Addendum 42 – UN Regulation No. 43

Revision 4 - Amendment 2

Supplement 6 to the 01 series of amendments – Date of entry into force: 19 July 2018

Uniform provisions concerning the approval of safety glazing materials and their installation on vehicles

Figure 4.1
Diagram of abrading instrument

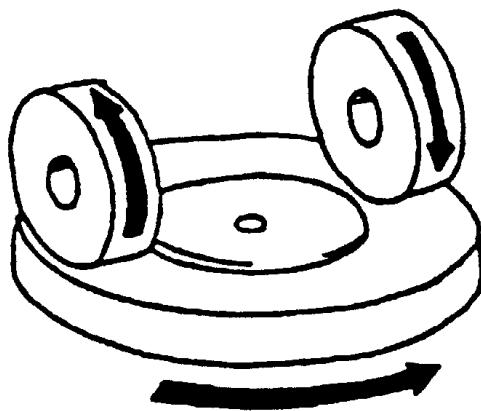
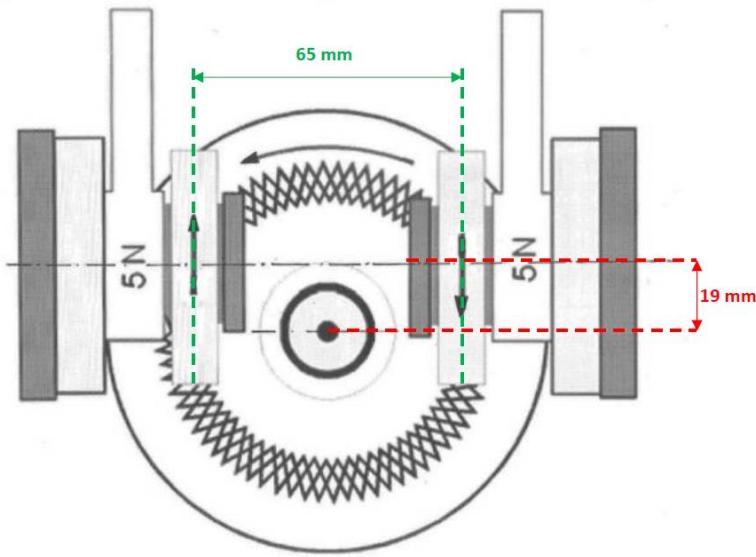
Paragraphs 4.1.1. to 4.1.2., amend to read (renumbering Figure 4 to 4.1 and inserting a new Figure 4.2):

"4.1.1. Abrading instrument¹, shown diagrammatically in Figures 4.1 and 4.2 and consisting of:

- (a) A horizontal turntable, with centre clamp, which revolves counter-clockwise at a fixed speed of 60 ± 2 rev/min or 72 ± 2 rev/min;
- (b) Two weighted parallel arms each carrying a special abrasive wheel freely rotating on a ball-bearing horizontal spindle; each wheel rests on the test specimen under the pressure exerted by a mass of 500 g. The distance between the internal faces of the wheels shall be $52.4 \text{ mm} \pm 1.0 \text{ mm}$ (which corresponds to a distance between the symmetry planes of the wheels of 65.1 mm). The horizontal offset of a virtual line, which

runs through both wheel axes, from the turntable axis shall be 19.05 mm ± 0.30 mm;

- (c) A vacuum suction system (not depicted in Figures 4.1 and 4.2) and vacuum pick-up nozzle to remove debris and abrasive particles from the test piece surface during testing. The height of the vacuum pick-up nozzle shall be adjustable, and the nozzle openings shall have a diameter of 11 mm.

Figure 5.1
Hazemeter

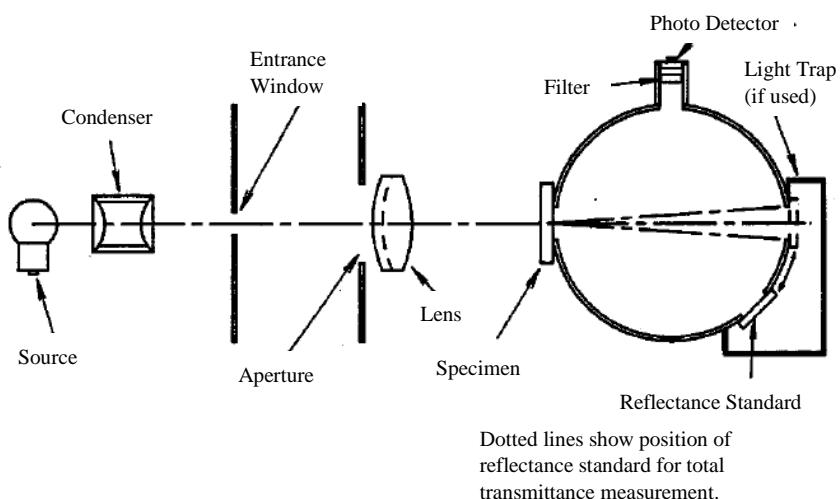
Paragraphs 4.1.4. and 4.1.5., amend to read (also replacing Figure 5.1):

- "4.1.4. Illuminate the test piece by a substantially unidirectional beam; the maximum angle that any ray of this beam may make with the beam axis shall not exceed 0.05 rad (3°). This beam shall not be vignette at either port of the sphere.

When the test piece is placed against the entrance port of the integrating sphere, the angle between the perpendicular to the test piece and a line connecting the centres of entrance and exit ports shall not exceed 0.14 rad (8°).

An aperture or diaphragm shall be centrally inserted in the haze measuring apparatus to centre the light beam on the abradant track and limit it to a diameter of $7\text{ mm} \pm 1\text{ mm}$ at the test piece.

When the reduced light is unobstructed by a test piece, its cross section at the exit port shall be approximately circular, sharply defined, uniformly bright, and concentric within the exit port, leaving an annulus of $0.023\text{ rad} \pm 0.002\text{ rad}$ ($1.3^\circ \pm 0.1^\circ$) subtended at the entrance port.

Figure 5.2
Abraser turntable with test piece mounted at 45° from machine front

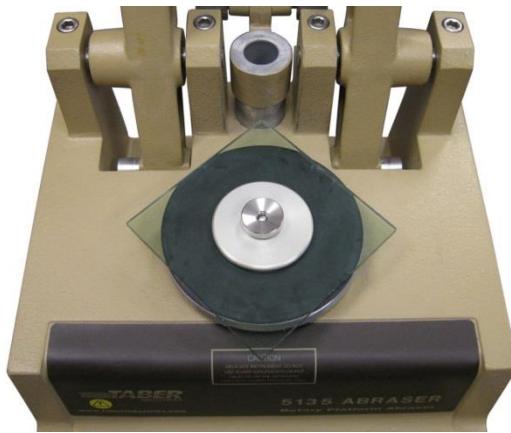
Insert new paragraphs 4.4.4. to 4.4.6., to read (inserting also new Figure 5.2):

Mount the test piece on the abraser turntable platform with the side to be abraded facing up. The test piece shall be mounted at a 45° angle from the front of the machine as shown in Figure 5.2. Secure using the clamp plate and nut. Affix the load corresponding to a total load of 500 g (per wheel) to the abraser. Lower the vacuum pick-up nozzle and adjust the height to 1 mm above the test piece surface with a gage having a thickness equal to 1 mm or a gage pin having a diameter equal to 1 mm. After setting the height of the vacuum nozzle, ensure the rear vacuum nozzle does not contact the test piece surface.

"Figure 2a:

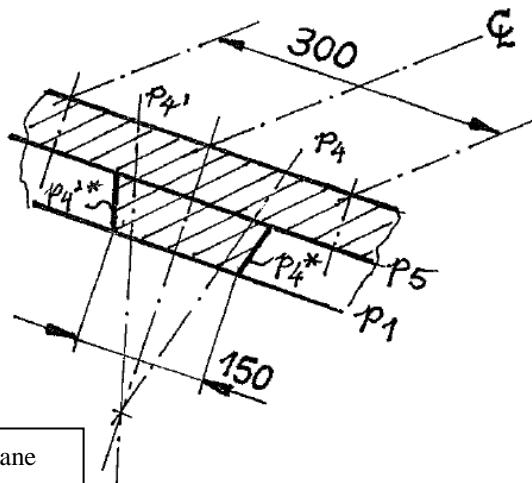
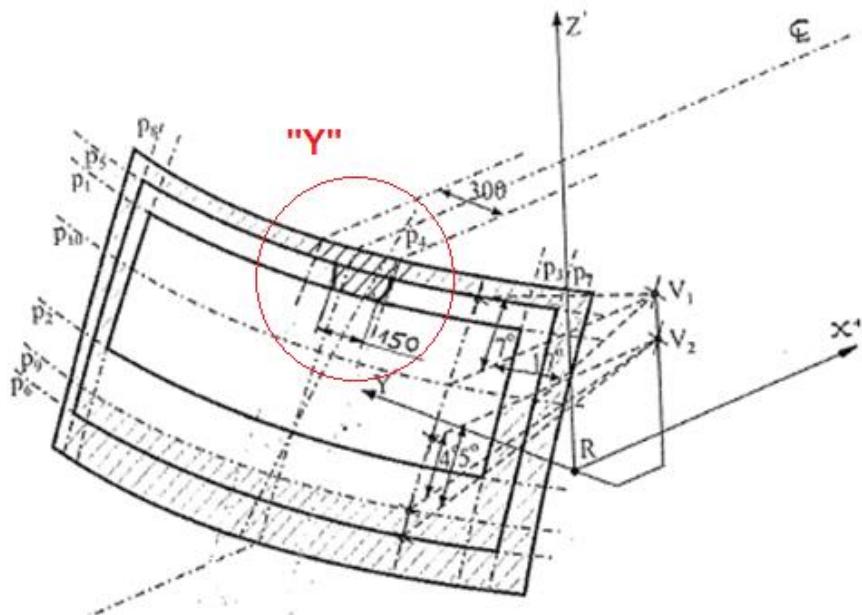
Annex 21, Figure 2a, amend to read:

Reduced test area "B" (example of a left-hand steering control vehicle) - upper obscuration area as defined in paragraph 2.4.2.2.
